Response to the Reviewer's comments - review 1

Investigation into instantaneous centre of rotation for enhanced design of floating offshore wind turbines.

Response to the Reviewer’s comments - review 2

Figure 1: ICR statistics for different one-at-a-time design variable perturbations for a spar FOWT. Original design values marked with black outline.

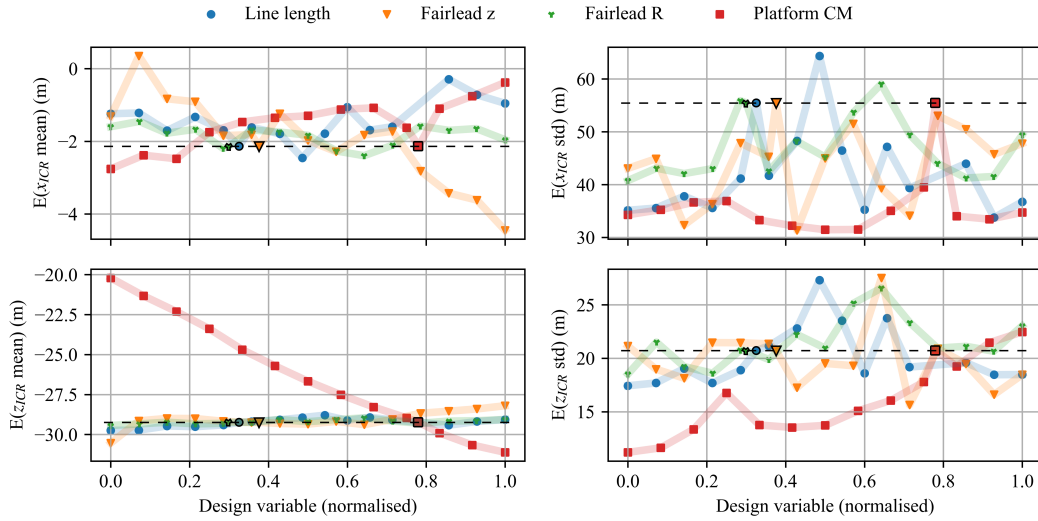
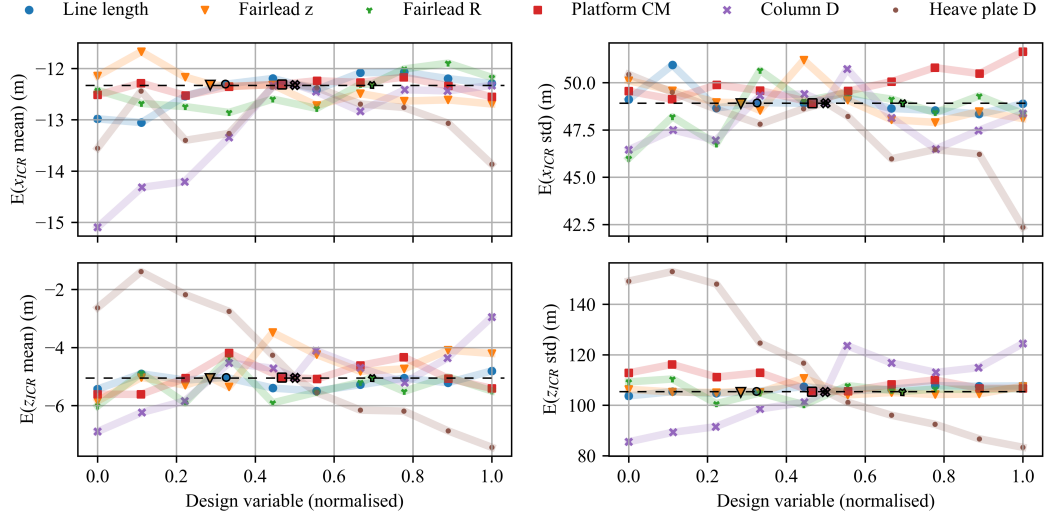
Comment 7 "Figure 17: Why do the original design values show different ICR values? Shouldn't all original design values share the same ICR value? The original design values should all represent the same original design configuration and thus have same result values".

Response 7 Thank you for noticing this, that is correct. The results were generated by systematic variations of the variables between the minimum and maximum values and the original design values were not always part of the design matrix; the markers corresponding to the original designs were mislocated.

Modification 7 We have now added the results of the original design and marked the correct original design values in Figures 19 and 20 (note that these are also updated in response to other comments).

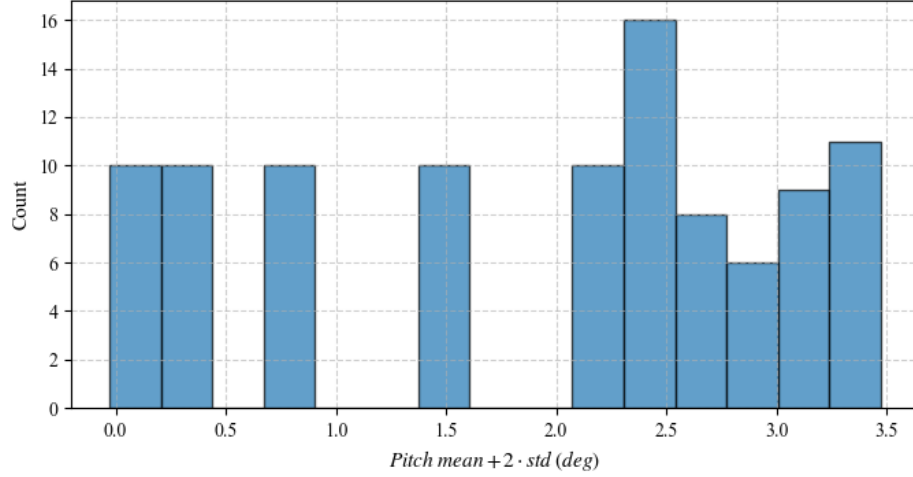
Comment 10 ”Table 13. (Offset column d, mean Re-vol. value 8.38): Offset column has a major impact on hydrostatic stiffness and restoring. Reducing the parameter by this extend is would probably result in insufficient floating stability thus large tilt during power production and even risk of capsizing/downflooding”.

Response 10 We double-checked the maximum pitch angle from the simulations of the different variants of the semisubmersible, as presented in the figure below. All designs had sufficient stability in all conditions considered (including that of maximum thrust).

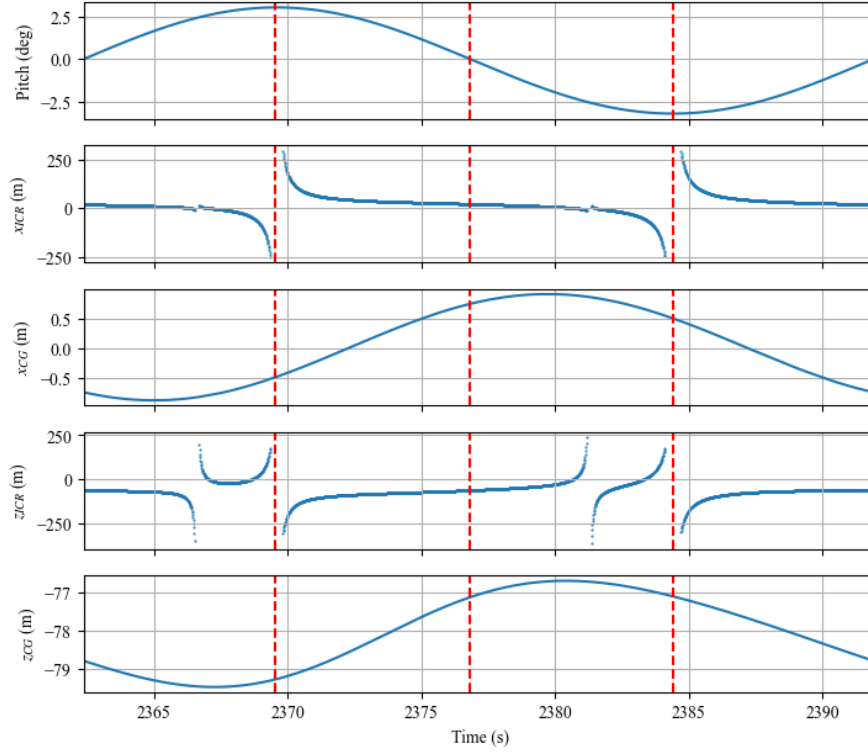
Comment 16 "Line 196: Do you assume a constant current profile? Please clarify".

Response 16 The sub-surface current follows a power law. We vary the velocity at still water level while leaving the power law exponent unchanged at value $1/7$.

Modification 16 We modified the text of Section 3.1 Study setup: "Group F adds the effect of the subsurface current speed (the power law exponent is kept at the value $1/7$)".

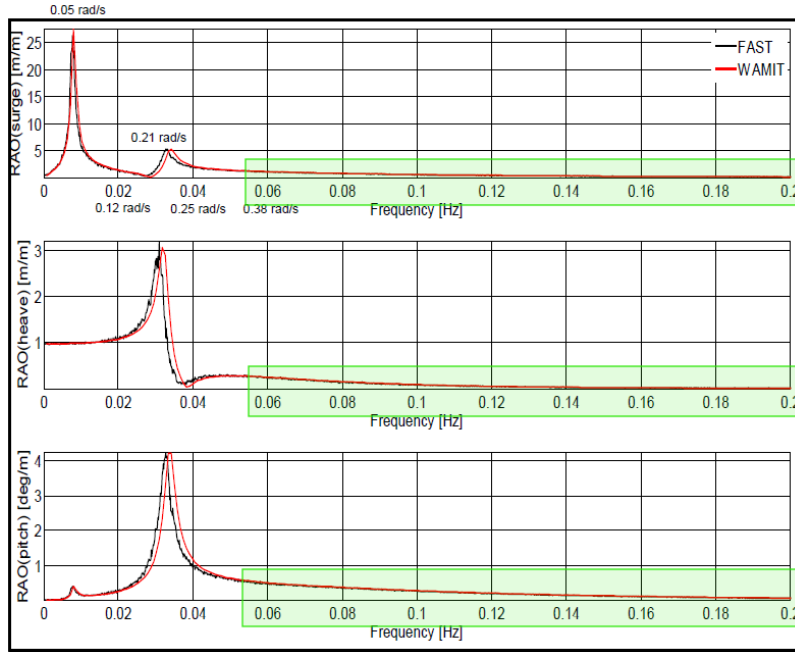
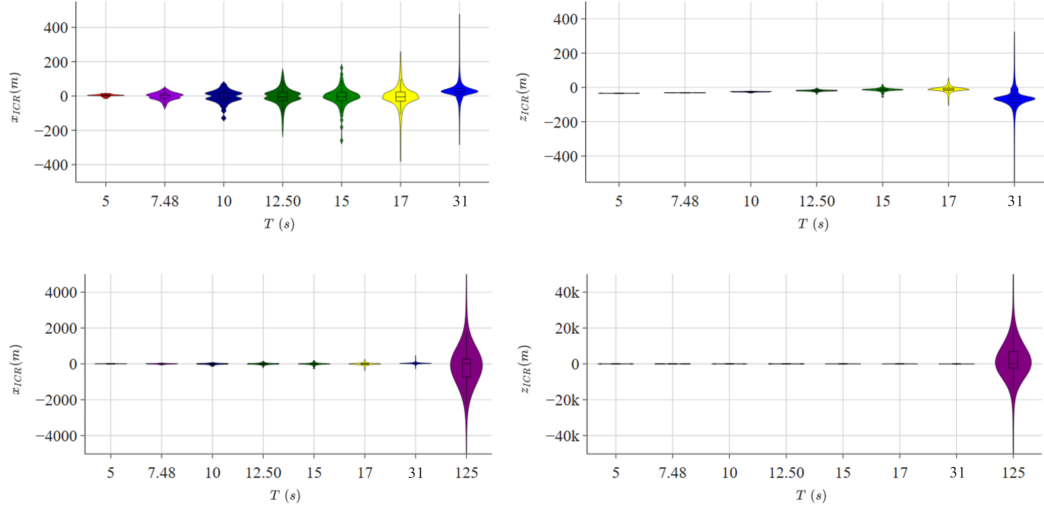
Comment 18 "Line 204: The longest period considered is 17.0 s. It is hard to believe that these waves will excite surge ($T_n = 125$ s) very significantly. Even the heave natural period (31 s) is a bit

far from that. What is the pitch natural period? If it is not much longer than 17 s, could it be that the increased surge motion is actually caused by coupling with pitch?”.

Response 18 Thank you for your careful assessment of the discussion. We did not present the results for periods higher than 17s as such long waves are rare in real sea states, based on the metocean data. We did analyse the cases of 31 s (pitch natural period) and 125s (surge natural period), and these resulted in very wide ICR distributions, as presented in the figure included below.

The mechanism leading to the increase of ICR distribution width is the increase of the system response with the exciting frequency decreasing from very low towards the region of the natural frequencies of the system. As seen in the plots below, the surge, heave, and pitch RAOs increase between the periods of 5 s and 17 s, therefore any given wave amplitude will exert higher motions at 5 s than at 17 s, in all rigid body modes.

Following the comment about the wave periods being far below the surge natural period, we performed a more in-depth analysis of the velocities in two points on the structure: $z = -120$ m and $z = -12$ m, as considered for ICR calculation, and concluded that two different mechanisms drive the ICR distribution width, one mechanism close to the pitch natural period, and a different one close to the surge natural period, as detailed in the modified text.

Modification 18 We updated the discussion in Section 3.2 accordingly: ”Two mechanisms are important: i) Difference in the horizontal velocity’s increase in two points on the structure due to increase in pitch motion as the wave period increases towards 31 s, and ii) Higher horizontal velocity in both points due to increased surge motion as the wave period approaches 125 s.
